CITY OF ALBUQUERQUE

Planning Department
Alan Varela, Director

RE: 4904 Cresta Del Sur Ct NE
Grading and Drainage Plan
Engineer's Stamp Date: 04/19/24
Hydrology File: F23D007B

ENGINEER'S SEAL	LOT 6 TRAILHEAD SUB. 4904 CRESTA DEL SUR CT NE	DRAWN BY DEM
DAVID SOULE NEW MEXICO PROFESSIONAL ENGINEER 14522	GRADING AND DRAINAGE PLAN	DATE 4-18-24
4/19/24	Rio Grande Engineering	4904 Cresta Del Sur Ct.DWG
DAVID SOULE P.E. #14522		SHEET # C1
		JOB #

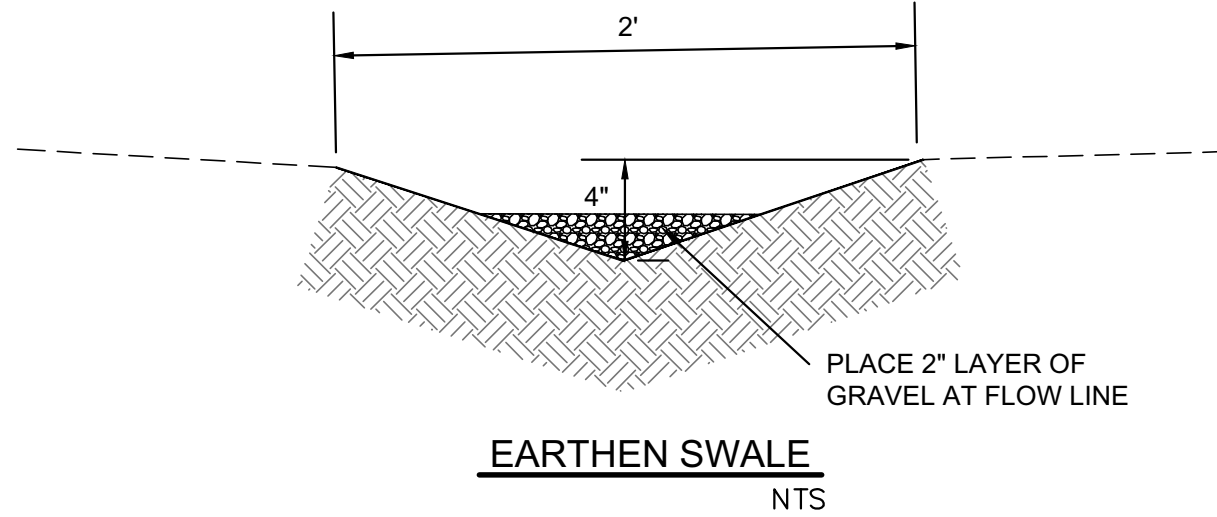
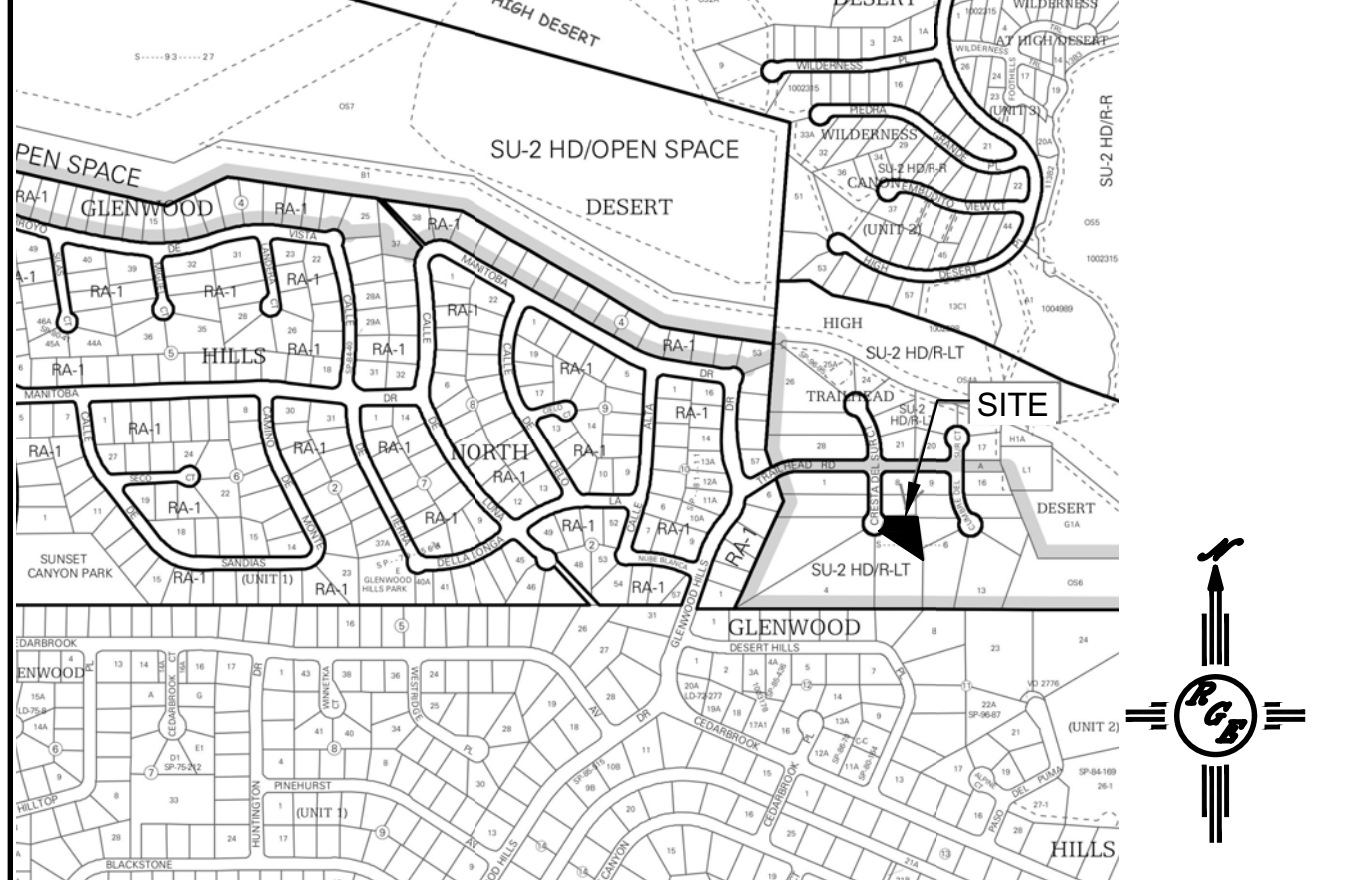
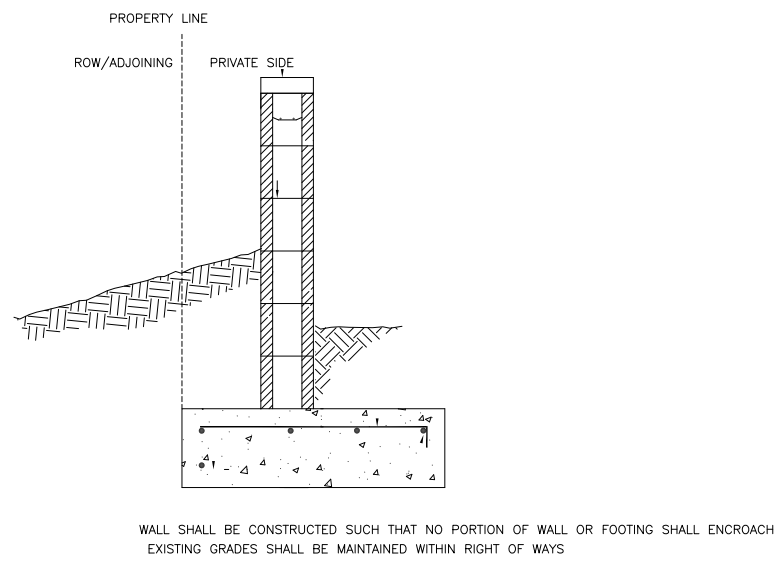
Based upon the information provided in your submittal received 07/16/2024, the Grading and Drainage Plans are approved for Building Permit and Grading Permit. **Since this site has stem walls, a pad certification is not needed for this project.** Please attach a copy of this approved plan in the construction sets for Building Permit processing along with a copy of this letter.

1. Engineer's Certification, per the DPM Part 6-14 (F): Engineer's Certification Checklist For Non-Subdivision is required.
